QUALITY ASSURANCE -- NON-CONFORMANCE RESOLUTION

Location: Changxing Island, Shanghai, P.R. China**Report No:** NCS-000523**Prime Contractor:** American Bridge/Fluor Enterprises, a JV**Date:** 11-Mar-2010**Submitting Contractor:** Zhenhua Port Machinery Company, Ltd (ZPMC), Changxing Island **NCR #:** ZPMC-0522**Type of problem:**

Job Name: SAS Superstructure
Document No: 05.03.06-000510

Reference Description: Missed UT Indication by QC, Segment 7CW

WELD NUMBER: SSD13A-PP54-007

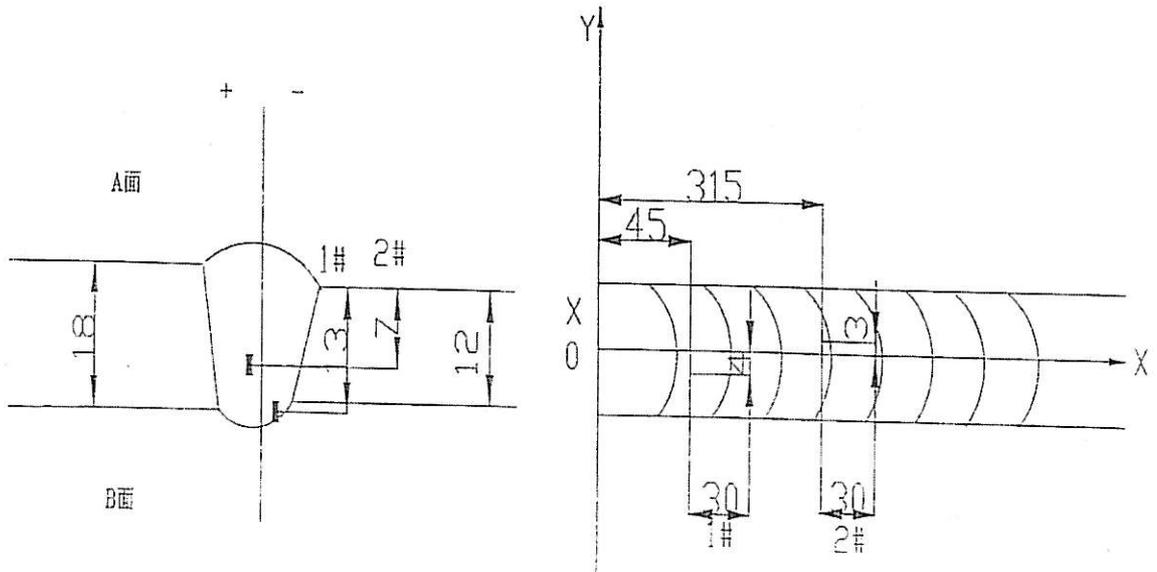
焊缝缺陷描述:

Description of welding discontinuity:

Rejected indication found by ultrasonic inspection is less than the maximum allowance aggregate length.

(UT探伤发现的缺陷总长度小于最大允许长度。) SSD13A-PP54-007

Caused:

1. Did not clear the weld pass completely in time.

Disposition :

1. Gouge or grind from nearer side from metal edge ($D \leq 0.65T$, "D" is depth of defects, "T" is thickness of metal) to remove all defects;
2. Follow repair WPS for joint preparation, preheat, and weld deposit;
3. Verify with VT no defects remain in the weld joint prior to welding;
4. Grind the repaired area flush with base metal or the adjacent weld;
5. Perform UT inspection to the weld along with 50mm on each end of the repair area.
